Meeting Notes

Subject	Bridge Approach Design Option Agency Meeting	Sheet 1 of 13
---------	--	---------------

Project Number	21132
----------------	-------

Meeting Date	August 19, 2005	Meeting Location	4 th Floor Conference Room
--------------	-----------------	------------------	---------------------------------------

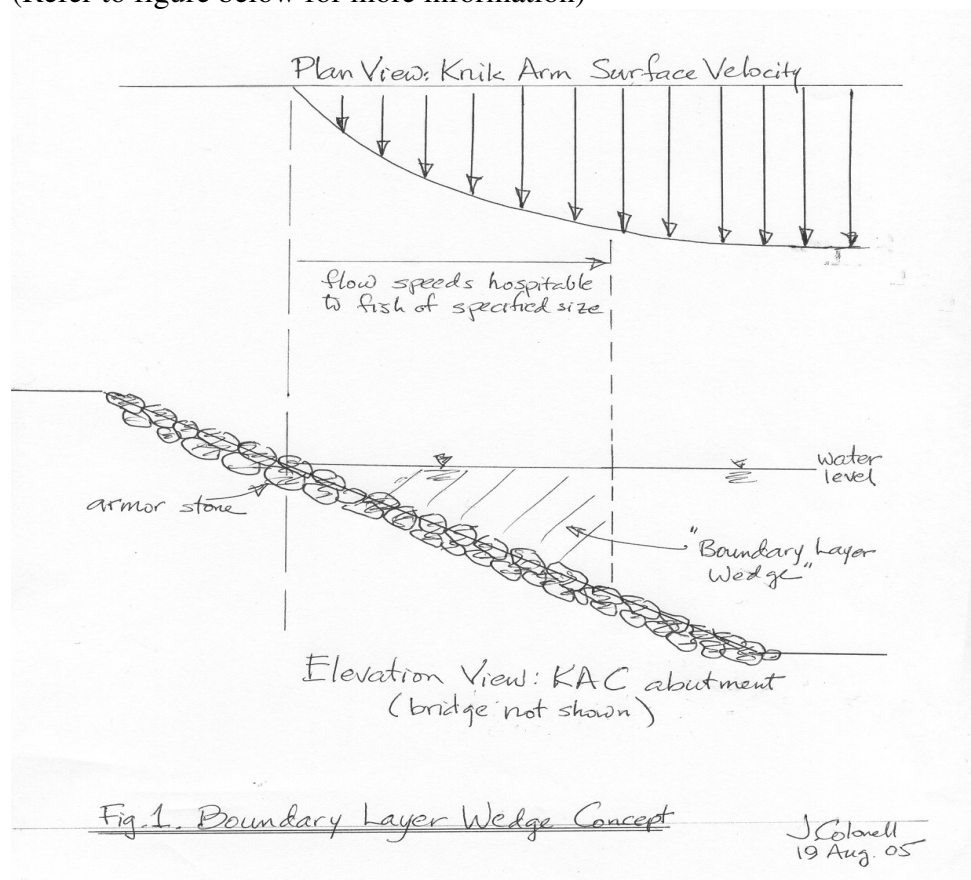
The circles Robin has put on the print out illustrates where there may be a greater biological concern (referring to the NOAA water level figure handout).

All fluid flows are impeded in the vicinity of solid boundaries. The amount of impedance, or slowing, of the flow is a function of the amount of solid boundary in contact with the flow, called the “wetted perimeter,” and the roughness of the boundary itself. Accordingly, flow past the distal ends of the earthen embankments of the KAC will be similarly impeded. Indeed, there will be a wedge-shaped volume of that flow, called the “boundary layer wedge,” within which flow velocities will be sufficiently impeded (i.e. lowered) to accommodate the needs of smaller fishes for lower flow speeds to navigate their way past the embankments (see Figure 1).

Analyses are underway to determine both minimum size of the boundary layer wedge (for a specific fish length) and the duration of least hospitable wedge size (again a function of the fish length). Initial results indicate that the wedge size is more strongly related to boundary roughness than boundary slope. Results will be presented in a manner that depicts size of boundary layer wedge as a function of time within the tidal cycle, with boundary roughness and slope as parameters.

If we use abutment examples, number two would be the maximum slope you would want to use?

Yes
